To All Lamborghini Dealers and Licensed Service Point
From Customer Service Department
Subject Wiring Fixing
Group LB715.9.71
Attachments -
Date 28.08.2006
Pages 6

Wiring fixing

All MY06 Gallardo Spyder from VIN 3750 until VIN 4015.

Pict. 3

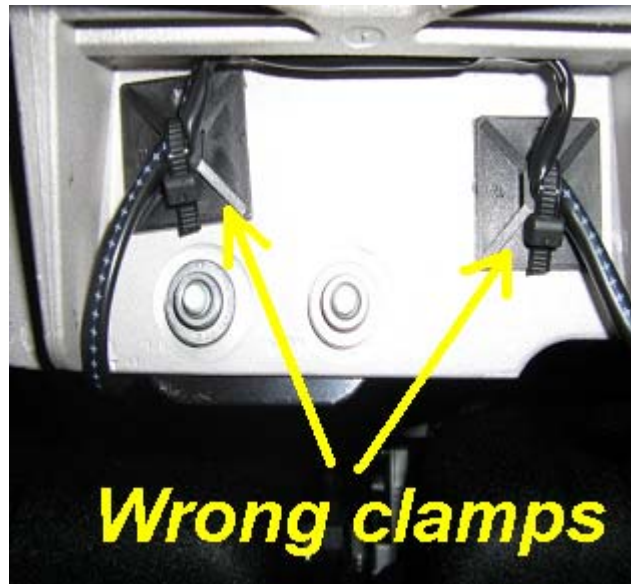
- 1.4 If the fixing device appears similar to picture 3, this should be replaced. The engine heat could unglue the clamps from the support.
- 1.5 Remove the incorrect clamps and replace them with the new ones as in pict. 4.

Pict. 4

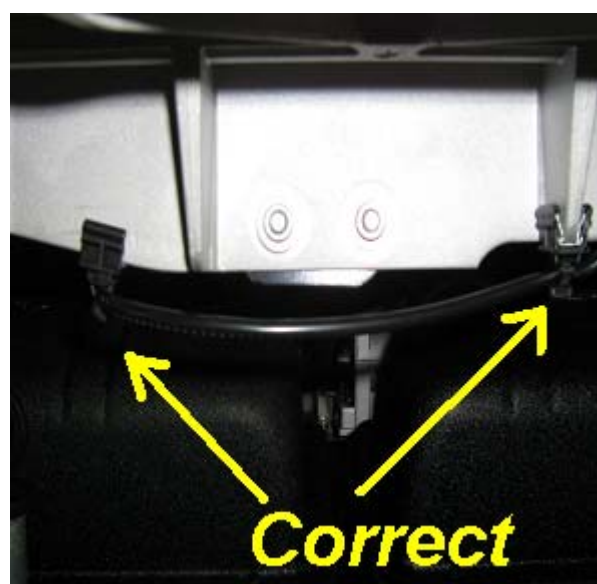
1.6 Utilizing this fixing device the cable will no longer be in contact with the hot engine parts.
